DART SERVICE BULLETIN SB10-1

AFFECTING:
D212-664-XXX AND D412-664-XXX CROSSTUBES

REF. TCCA STC: SH01-9
REF. FAA STC: SR01298NY
REF. EASA STC: EASA.IM.R.S.01304

FIGURE 1 - TYPICAL CROSSTUBE

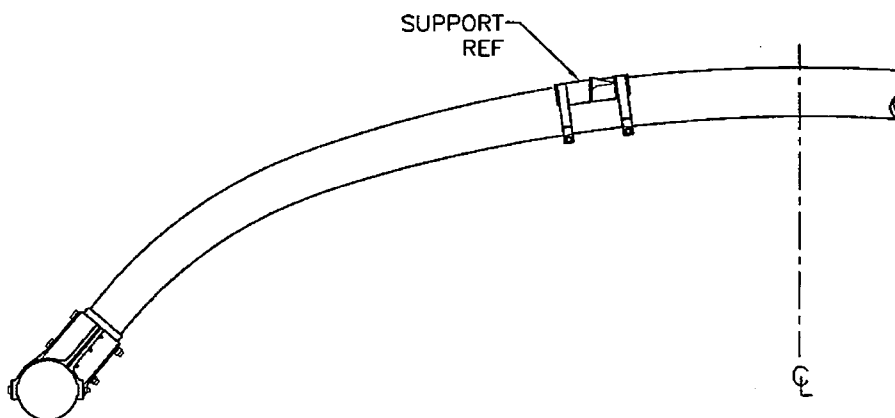
In response to the recent field failures, Dart has revised ICA-D212-664 to Revision 6 to clarify/enhance inspection procedures on the D212-664-XXX and D412-664-XXX Crosstubes. Section 5.3.1 provides better definition of how and where to look for cracks in the crosstube at the 300 hour inspection interval.

Per Section 5.4 of ICA-D212-664, customers need to remove the landing gear from the aircraft every two years to have a closer look at the crosstube in the vicinity of the supports. Damage within the acceptable limits must be repaired and the crosstube finish touched up per sections 5.3 of ICA-D212-664. If the supports are loose or shifting, they need to be removed and reinstalled per section 32.4 of ICA-D212-664 using Magnobond 6398.

Customers with D212-664-101/-201 crosstubes at CHG 002 (or earlier) or D412-664-203 crosstubes at CHG 003 (or earlier) should remove the supports at the next 300 hour inspection interval to inspect for damage and repair surface finish per section 5.3 of ICA-D212-664. Supports need to be re-installed per section 32.4 of ICA-D212-664, using Magnobond 6398 in lieu of the D2856-XXX abrasion strips.
